SUBJECT: Major Site Plan – preliminary & Final Site Plan Approval Application No. SP-1/22
1052 Spruce, LLC, 1052 Spruce Street
Tax Map Page 7, Block 701, Lot 39

DATE: April 8, 2022

Re: **1052 Spruce, LLC**
Preliminary and Final Major Site Plan
Block 701 Lot 39
1052 Spruce Street
AT-4 (Apartment and Townhouse 4) Zoning District
Application No. SP-1/22

SUBJECT: Spruce Street Apartments aka 1052 Spruce LLC
Preliminary & Final Site Plan w/Variance Application SP-1/22
Planning Board Memorandum #1
Lawrence Township Mercer County, New Jersey
Tax Map Page 7, Block: 701, Lot: 39

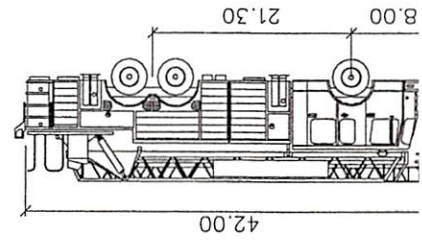
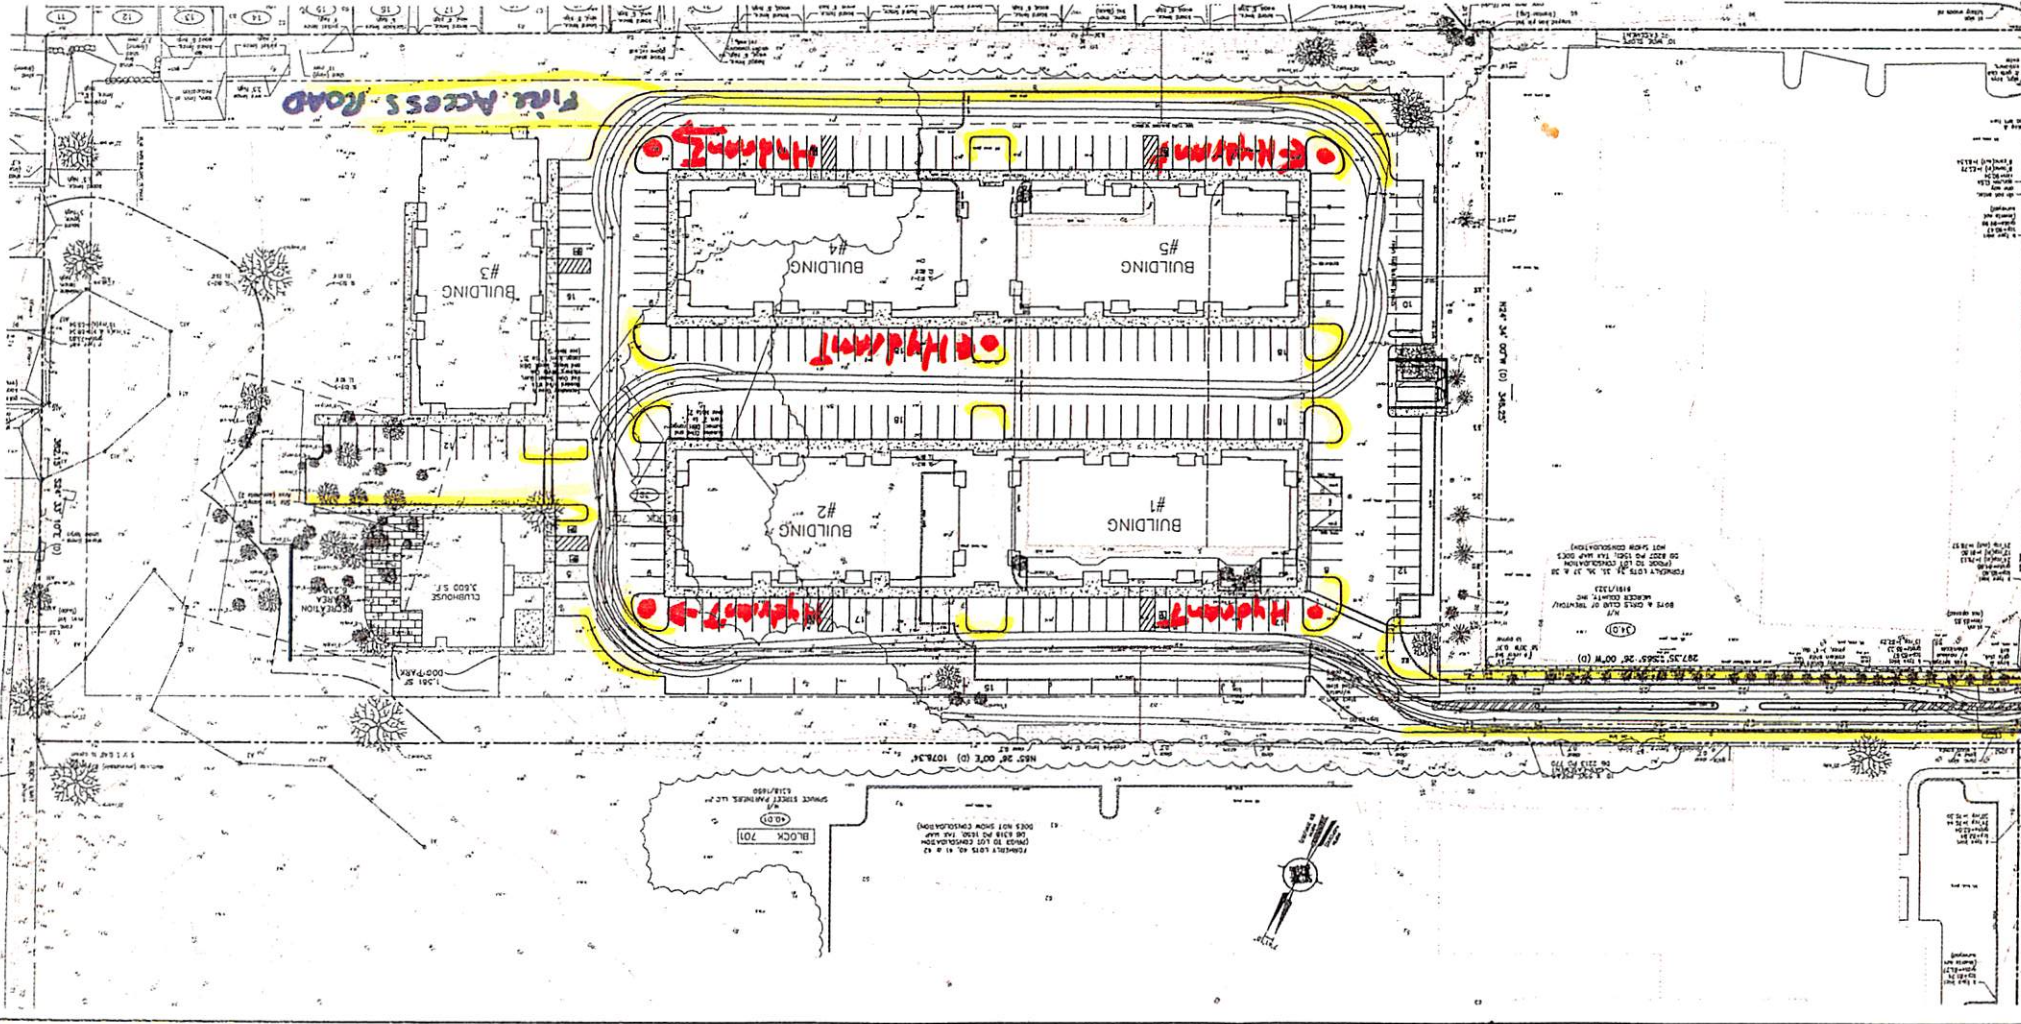
1. Due to one entrance into property, additional Fire Hydrants to be installed in complex. A Fire hydrant to be installed in center area between buildings # 4 and # 5 on island (site map attached) and 2 additional fire hydrants to be installed on opposing corners of property, corner of Building # 5 and corner of Building # 2 (site map attached). The purpose of additional Fire hydrants is to prevent further access restrictions when the fire apparatus deploys large diameter hose in event of fire. Additional fire hydrants will also prevent delays while establishing water supplies, fire apparatus placement and connecting to buildings fire department connection.

2. Fire Lane Markings and proper "NO PARKING FIRE LANE" signs to be installed in main entrance/ exit driveways both sides. Curb line on south side adjacent to Tiffany Woods Drive, all areas indicated in highlighter on site map provided. Allowing appropriate access for Fire Apparatus from main entrance driveway to rear of building.

3. Fire access road on south side of Building # 3, adjacent to Tiffany Woods Drive. This access road is for the fire department ladder truck to access the rear of Building # 3 in event of emergency. Roadway to be constructed according to specifications of the Lawrence Township Engineering Department. The roadway to extend past rear of building no less than 30 feet.

- Fire Hydrants Total 5
- Fire Lanes Markings in Roadway & Signs
- "No Parking Fire Lane"
